Re: Driveway widening for 0 West Newell Avenue, Walnut Creek

Arborist Report Addendum

TP19-0036

Figure 1. Most recent plan showing new driveway, with updates to tree protection recommendations.

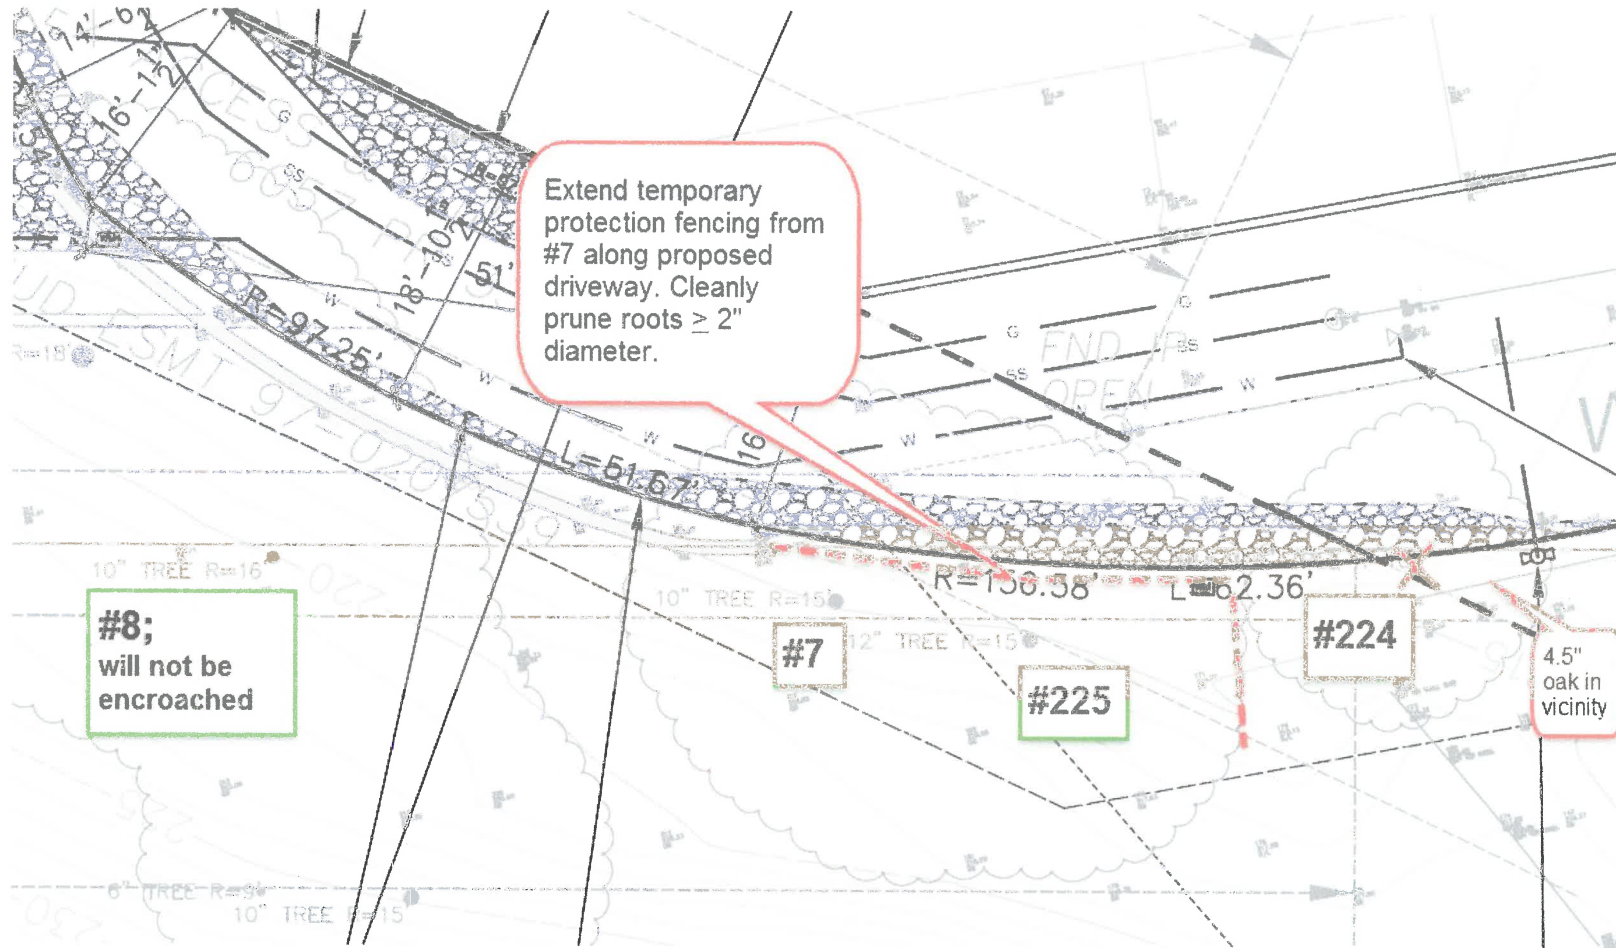
The road will be widened at the east end of the property, which occurs near tree #8 and two additional oaks (#224, 225). The tree protection recommendations from my 7/3/19 arborist report are still valid for trees #7 & 8. Root encroachment is acceptable for tree #225, but high for #224 since the driveway terminates 1' from the trunk.

- Remove tree #224.
- Prior to construction or grading, contractor shall install temporary fencing along the proposed driveway to construct a temporary Tree Protection Zone (TPZ) around the trees that will be retained. Heavy duty orange poly fencing may be used if it is securely attached to metal stakes spaced 6' apart. (change from previous report which specifically requested chain-link)
- If roots $\geq 2"$ diameter are encountered during excavation by trees #225, they shall be cleanly pruned, covered, and kept moist till backfilled.
